Preclosure Seismic Design Methodology and Performance Demonstration

*NRC/DOE Technical Exchange and Management Meeting
June 7, 2006*

**NRC Interim Staff Guidance,
Draft HLWRS-ISG-01,
*Review Methodology for Seismically
Initiated Event Sequences***

DOE YM Seismic Hazard

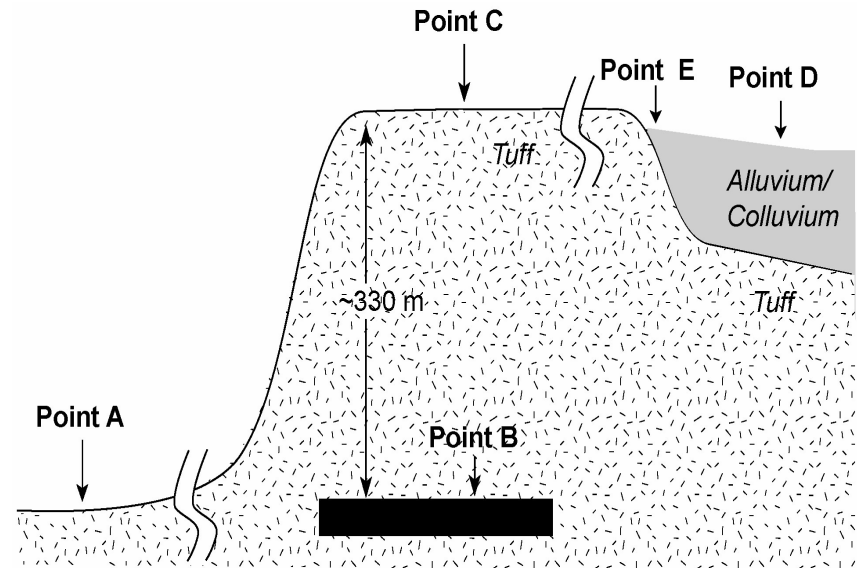
- YM PSHA (CRWMS M&O, 1998) provided hazard curves for Point A
- Site response modeling needed to obtain site specific hazard curves for points D, E, and B

- Site response modeling considerations:
 - 2D and/or 3D site effects
 - Nonlinear site-response model
 - Appropriate site geotechnical data
- Development of an appropriate site specific hazard curve
 - Incorporation of recent site response modeling results
 - Appropriate annual probabilities of exceedance

YM Mean Seismic Hazard Curve (Point A)

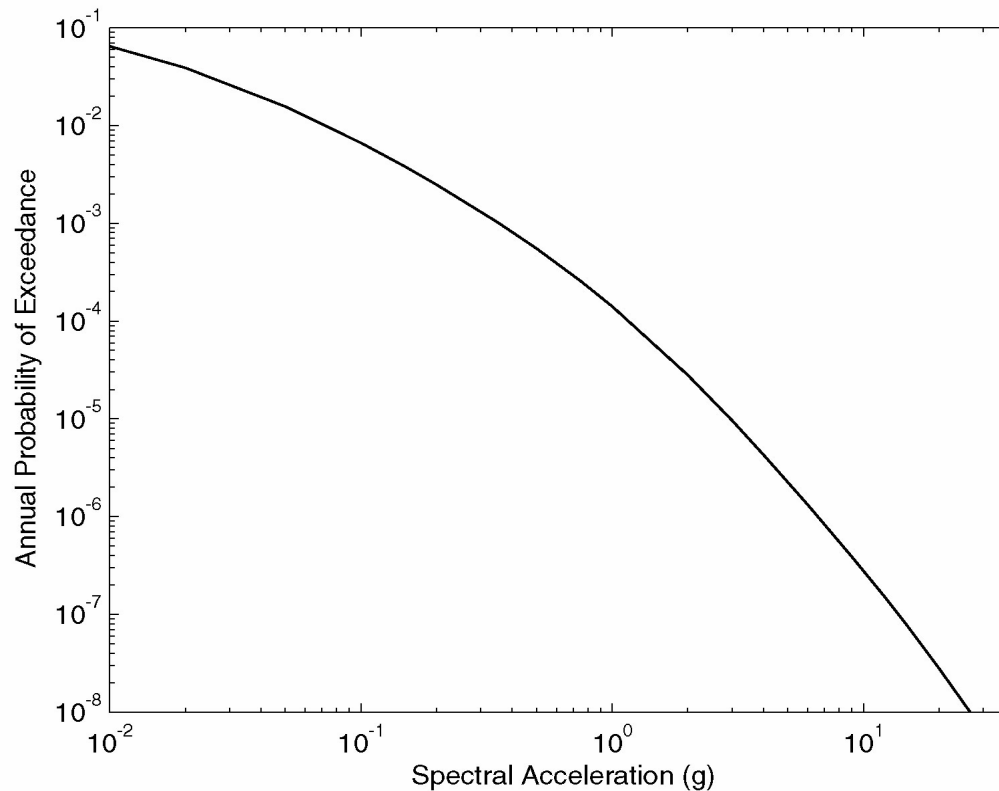
- DOE provided site specific response spectra at annual probabilities of exceedance of 10^{-3} , 5×10^{-4} , and 10^{-4} (Points D and E)
 - One-dimensional equivalent-linear modeling (Bechtel SAIC Company, LLC, 2004, MDL-MGR-GS-000003)
 - Site specific geotechnical data (Bechtel SAIC Company, LLC, 2002, ANL-MGR-GE-000003) for a portion of the Surface Facilities Area

- Seismic hazard for the preclosure safety analysis (PCSA) should be characterized to low-enough values of annual probabilities of exceedance so that its combination with fragilities of SSCs ITS will result in reasonable estimates of event sequence probabilities of occurrence, as required for Part 63 PCSA
